ADA Curb Ramp New Construction Inspection Form (Combination)

NW Curtis

NW Pacific

Ramp Style **C**

COMBINATION RAMP (C)

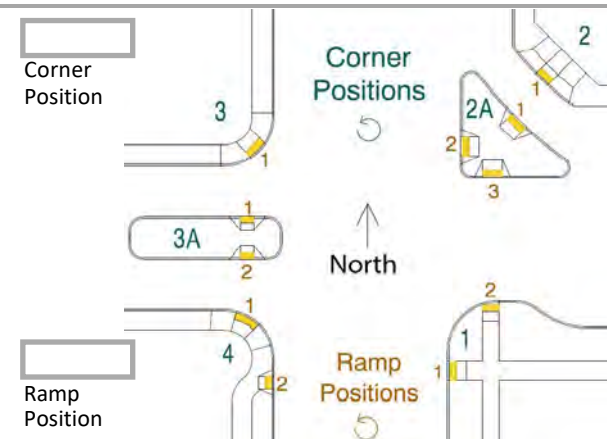
Ramp run 2, Ramp run 3, clear width less than 3ft
